North East Link Project

EES Inquiry and Advisory Committee (IAC)

Statement of landscape and visual amenity evidence

Stephen Schutt of Hansen Partnership Pty Ltd.

Figure 1: Diagrammatic representation of the composition of a panoramic photo to provide a horizontal field of view in the order of 100 degrees.

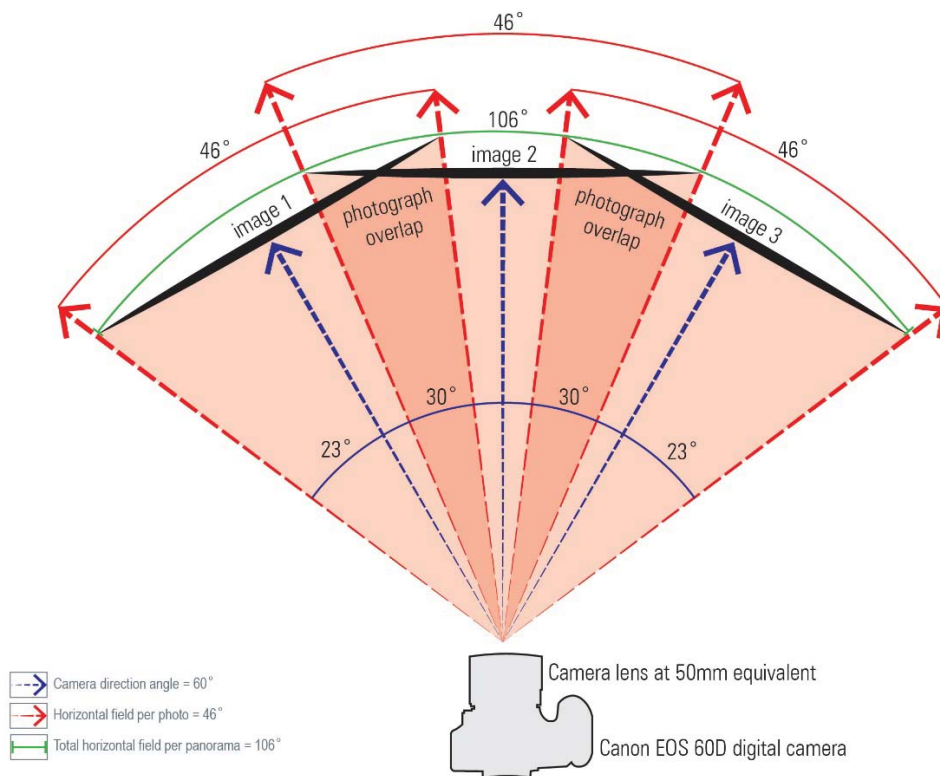
33. I note that many of the ‘photomontages’ provided within *Technical Report H* as the basis for demonstrating the visual impact of the Project do not represent a horizontal field of view of 80 or 100 degrees. It is my estimation that they represent a horizontal field of view of roughly half that extent. To demonstrate, the ‘photograph of existing conditions’ at Figure 3 below is a reproduction of Viewpoint 58 in EES *Technical Report H*, which – like every other Viewpoint in the EES *Technical Report H* is used as the basis for the preparation of subsequent ‘Photomontage’ images. By comparison, the panoramic photo in Figure 3 on the following page was taken by a Landscape Architect employed at Hansen Partnership, at a location estimated as being within very close proximity to Viewpoint 58 within *Technical Report H*. The panoramic photo prepared by my office utilised a full-frame digital camera with a 50mm lens, with a series of photos joined to form a panoramic view which comprises a horizontal field of view in the order of 106 degrees, consistent with the diagram provided in Figure 1 above.

Figure 16: Appendix A - Photomontage 15 Existing View from corner Sydney Street and Greensborough Road, facing east towards proposed ventilation building

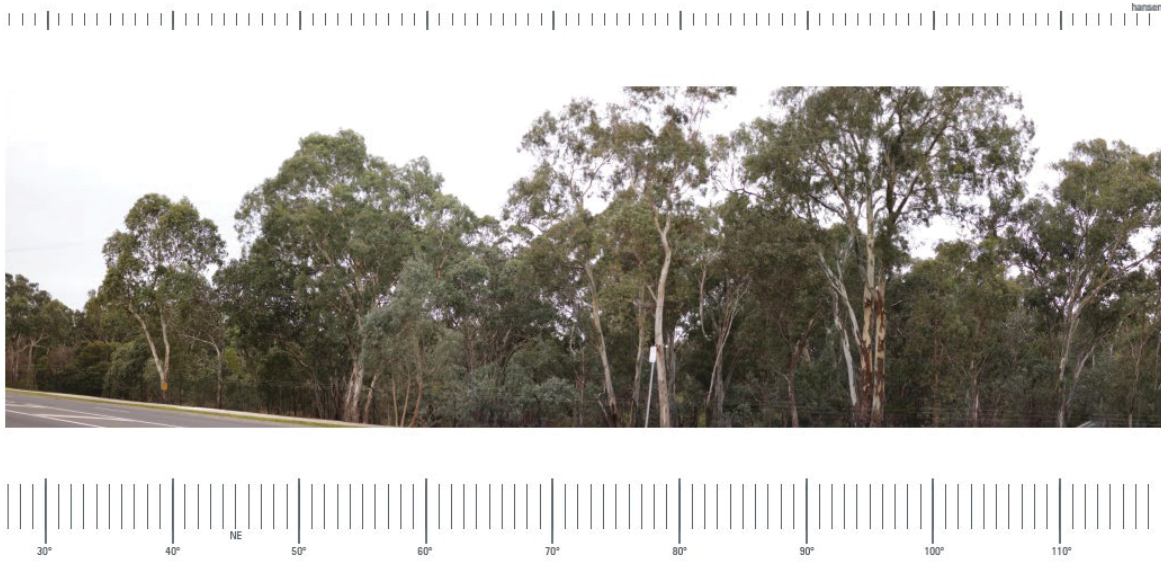
101. It is my opinion that a viewpoint located on the footpath on **Corner Sydney St and Greensborough Rd, Macleod** (*Refer Appendix A - Photomontage 15*), looking east toward the proposed ventilation building would show the full extent of visual impact experienced due to the proposed structure. This view is demonstrated in Figure 15 below.
